**Economic and Social Council**Distr.: General
26 September 2013

World Forum for Harmonization of Vehicle Regulations**Working Party on Passive Safety****Fifty-fourth session**

**Regulation No. 127 (Pedestrian safety) - Proposal for the 01 series
of amendments to Regulation No. 127****Proposal of 01 series of amendments to Regulation No. 127****Submitted by the experts from the informal working group
on global technical regulation No. 9 Phase 2***

The text reproduced below was prepared by the experts from the informal working group on global technical regulation No. 9 Phase 2 (GTR9-PH2) proposing provisions on pedestrian protection of motor vehicles. The modifications to the text of the UN Regulation are marked in bold for new or strikethrough for deleted characters.

Figure 7
Flexible lower legform impactor: Test set-up for the dynamic lower legform impactor certification test (inverse test, see paragraph 8.1.3.4.)

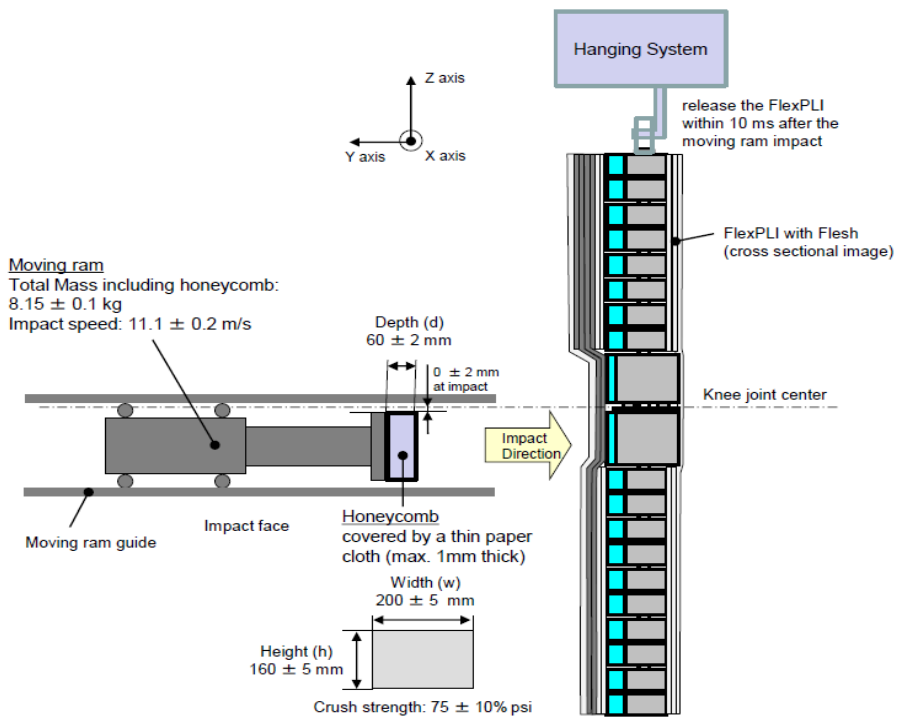
1.4.3.1. The assembled flexible lower legform impactor (with the flesh and skin) shall be hung vertically and freely suspended from a test rig as shown in Figure 7. It is then impacted by the upper edge of a linearly guided aluminium honeycomb impactor, covered by a thin paper cloth with a maximum thickness of 1 mm, at an impact speed of 11.1 ± 0.2 m/s. The

1.4.3.3. The upper edge of the honeycomb face shall be in line with the rigid plate of the linearly guided impactor. At the time of first contact, the upper edge of the honeycomb shall be in line with the knee joint centre line within a vertical tolerance of ± 2 mm.
